UNITED STATES PATENT AND TRADEMARK OFFICE

APPLICATION NO.	FILING DATE	FIRST NAMED INVENTOR	ATTORNEY DOCKET NO.	CONFIRMATION NO.
10/676,982	10/01/2003	Christian L. Belady	10018060-3	7690

Office Action Summary

DETAILED ACTION

Figure A: The modified figure corresponds to figure 6 with flushed surface shown

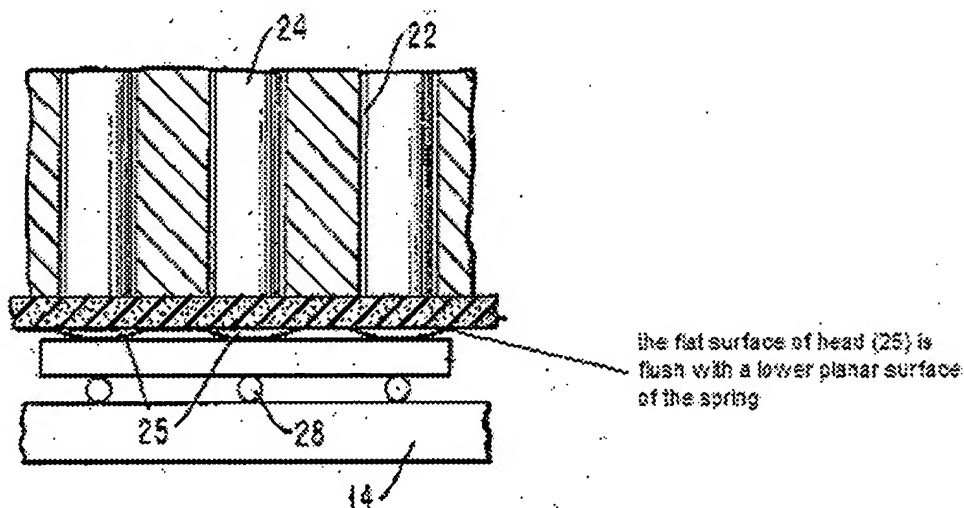
Applicant's arguments filed 4/19/2005 have been fully considered but they are not persuasive. Applicant's argument that the spring element (36) in Chu'281 is not flush to any head of the pin (24) has been very carefully considered but is not deemed to be persuasive because Chu'281 discloses (figure 6) that the lower planar surface of the spring element (36) is flush with a flat surface of the pin head (25). See figure A bellow.

Figure B: The modified figure corresponds to figure 2 of Chu'358 with limitation shown

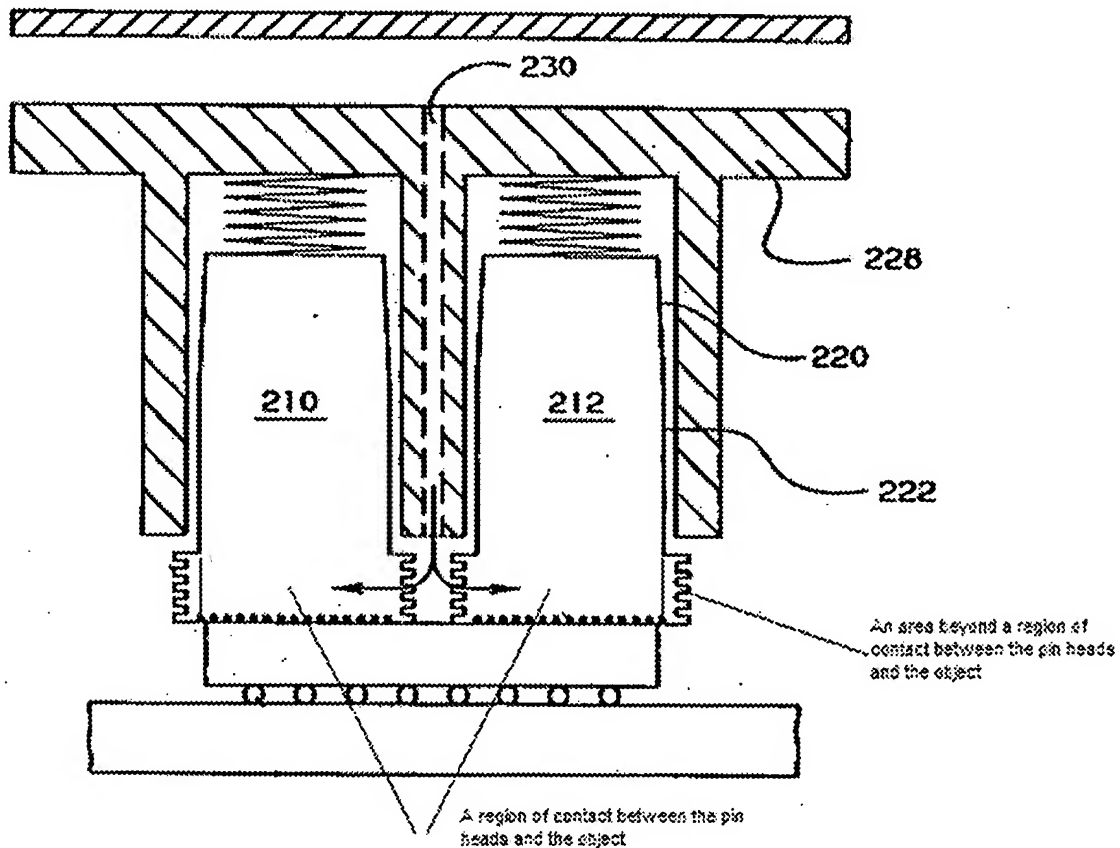
Regarding claim 12, applicant's argument that Chu'385 fails to disclose "the pinheads arranged in geometric pattern that covers an area extending beyond a region of contact between the pin

heads and the object" has been very carefully considered but is not deemed to be persuasive.

Chu'358 discloses figure 2 that the pins (210,212) have their heads arranged so that the pinheads also covers an area extending beyond a region of contact between the pin heads and the object.

(See figure B bellow).
